VALIDATION OPINION

**(Permanent Change to the Monitoring Plan
as Described in the Registered PDD)**

Report No: CDM-VER-2012-0043 (Permanent Change)
Date: 13/09/2012

Project Title: 48 MW Duduluo River Hydroelectric Power Plant

Figure 2: The description of the installation of monitoring meters in the proposed revision of the monitoring plan

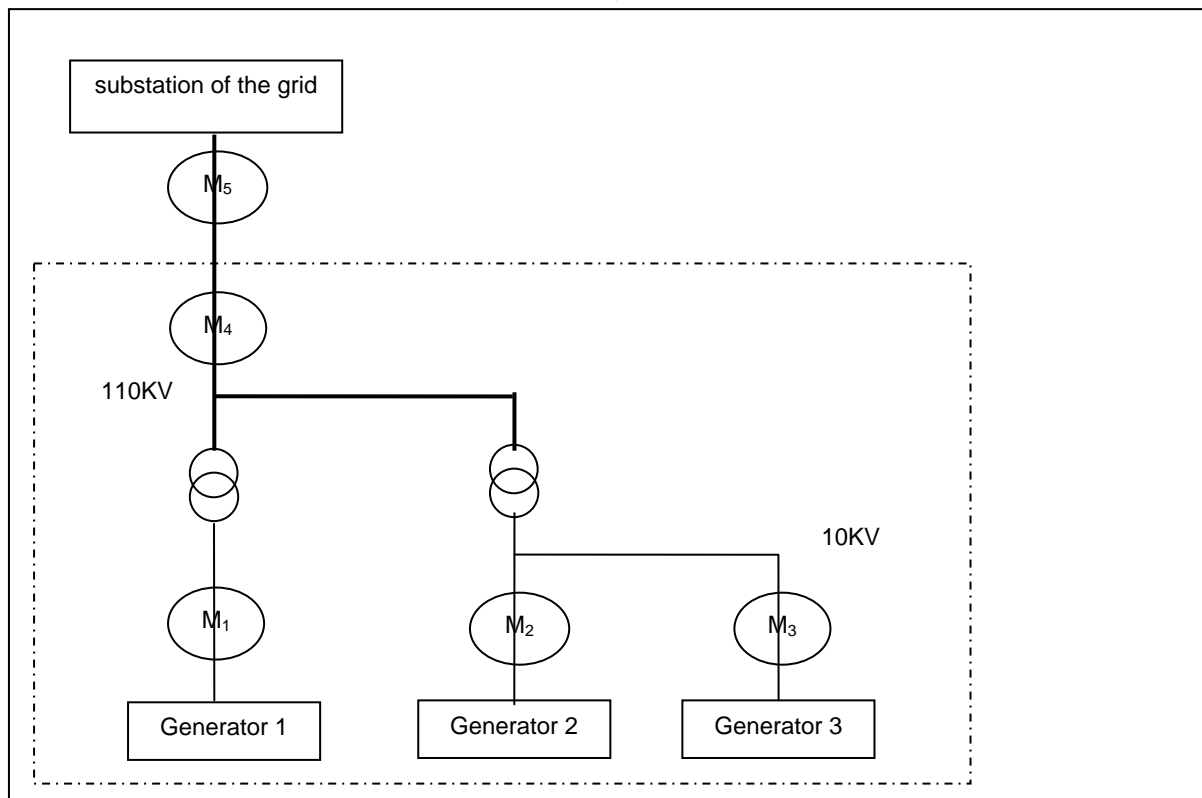
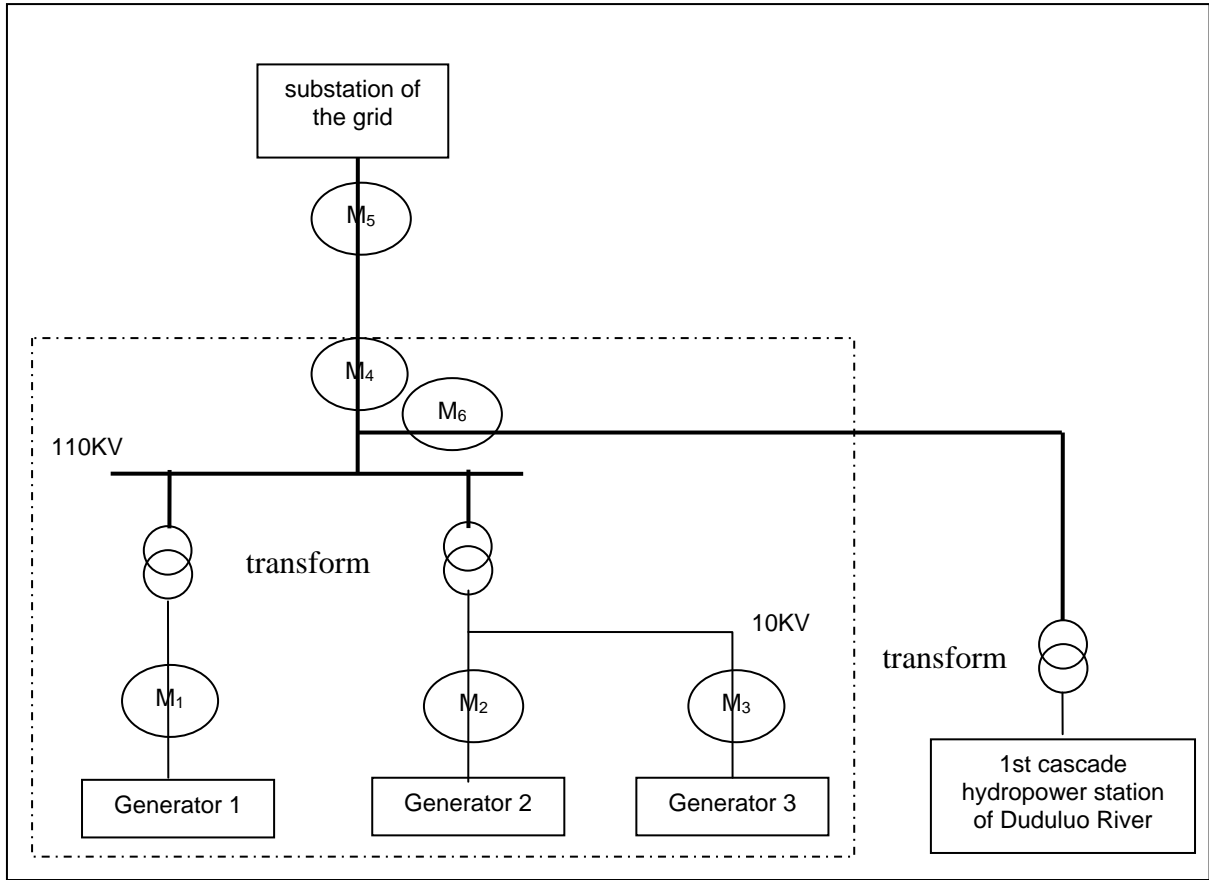
discovered that the number of the meters installed on-site used to monitor the EG_y is inconsistent with the registered monitoring plan.

Before, the 1st Cascade Hydropower Station of Duduluo River put into operation, the electricity supplied by the project can be measured by the master meter (meter M_5) which was installed at the substation side of transmission line. The readings of Master Meter are used for calculating the emission reductions when they are in normal operation status. i.e. $EG_y = EG_{M5}$, as shown below.

As described in the "Explanation of the T connection of 1st Cascade Hydropower Station of Duduluo River and 2nd Cascade Hydropower Station of Duduluo River" issued by the Dispatch Control Center of local Power Grid Company^{/6/}, after the 1st Cascade Hydropower Station of Duduluo River put into operation on 26/02/2012, the 1st Cascade Hydropower Station of Duduluo River has to share the same transmission line with the project to delivery the electricity to the grid, which means the electricity generated by the 1st Cascade Hydropower Station of Duduluo River would be delivered to the output side of transformer of the project first and then delivered to the substation of the grid via the shared transmission line. The actual monitored activity is illustrated as follows:

However, as there are two meters applied to measure the net electricity supplied by the project, it is necessary to consider the propagation of error of monitoring system. The accuracy of M5 and M6 is 0.5s, after the propagation of error, the accuracy of M5-M6 is calculated as $\sqrt{0.5\%^2 + 0.5\%^2} = 0.71\%$. Therefore, the 0.21% decrease of the accuracy level should be separately deducted from the measuring result of EG_{out} and EG_{in} for the conservativeness.

$$EG_y = EG_{out} - EG_{in}$$

$$EG_{out} = (EG_{out,M5} - EG_{out,M6}) \times (1 - 0.21\%) = (EG_{out,M5} - EG_{out,M6}) \times 0.9979$$

$$EG_{in} = (EG_{in,M5} - EG_{in,M6}) \times (1 + 0.21\%) = (EG_{in,M5} - EG_{in,M6}) \times 1.0021$$

Therefore, CQC validation team confirms the level of accuracy of the proposed revision of the monitoring plan is not reduced compared with the requirement contained in the registered monitoring plan.
